SUBJECT: Site Plan Review for 1936 Georgetown Road – Highfields Event Center

PC Case No: 2015-14

RE: PC 2015-14- Highfields Event Center

Re: High fields Event Center – 1936 Georgetown Road

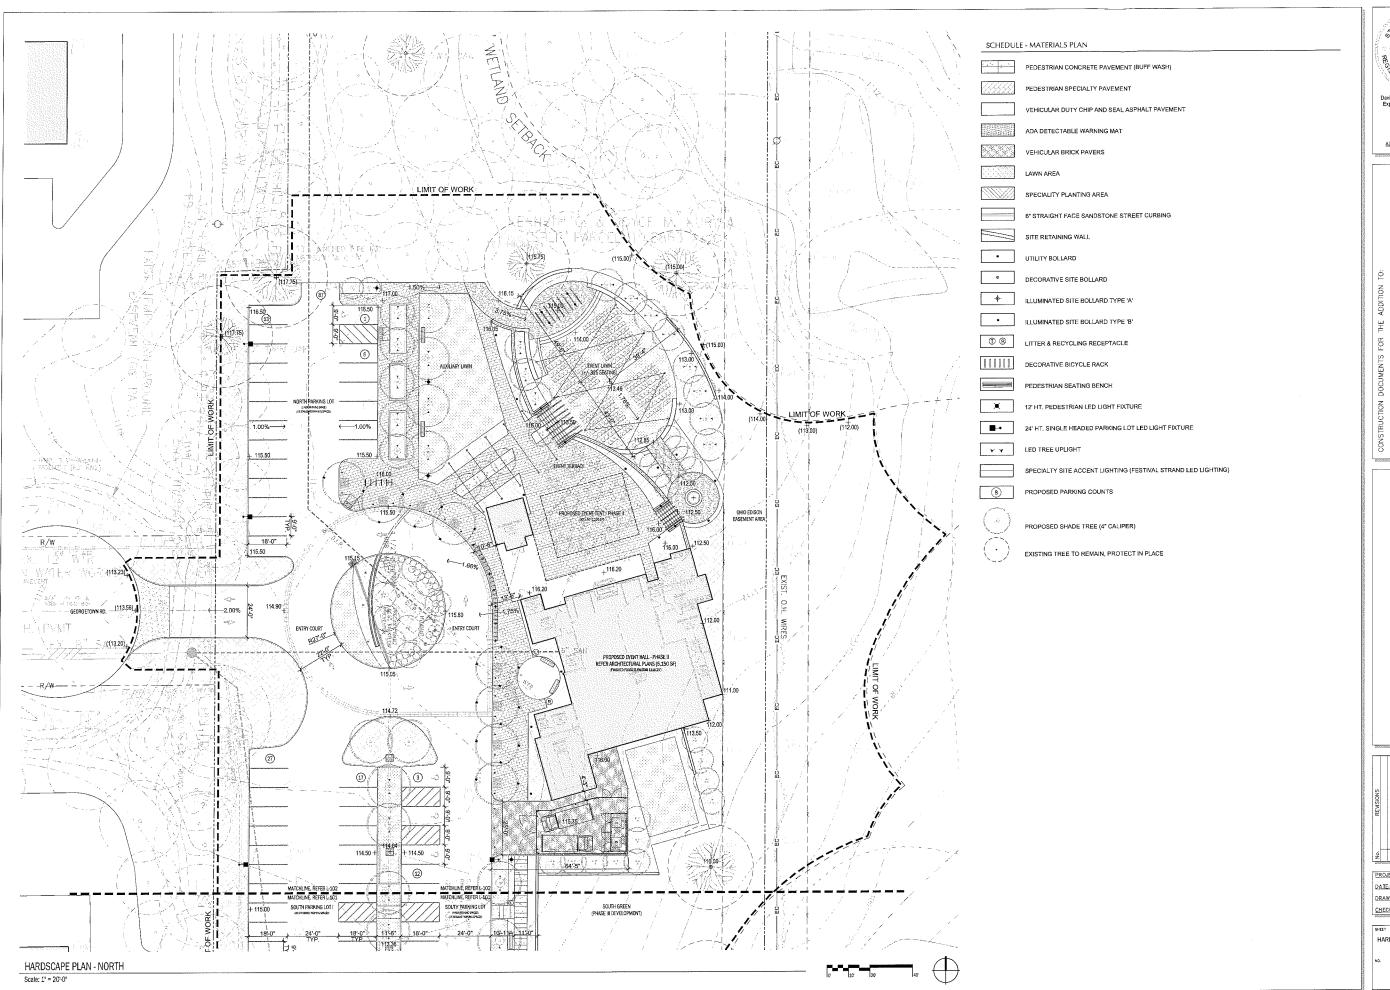
- C101- Waterline Size 8 inch vs. 6 inch? Is the 8" line required for the fire system?
- C101 An Air Release device is shown on the plans. Please explain the need for this device and if there is another method that can be used. (I.e. Fire Hydrant.)

- C101 Label the material type on water line. (Class 52 D.I.P). Less than 2" diameter = Type K copper.
- C101 Label the type (note: type shall be in compliance with the Hudson Water Standards) of all bends and appurtenances on waterline plan.

- C101 The City does not permit the use of underground vaults. Please explain the need for this vault on the waterline. Contact our office to discuss this item.

- C101 Show the proposed waterline on the profile and the vertical distances to any utility crossings.
- An ingress/egress access easement will be required from Georgetown Rd. to domestic
 water service valve location. Please contact our office to discuss this and the
 configuration of the domestic and fire systems near the building.
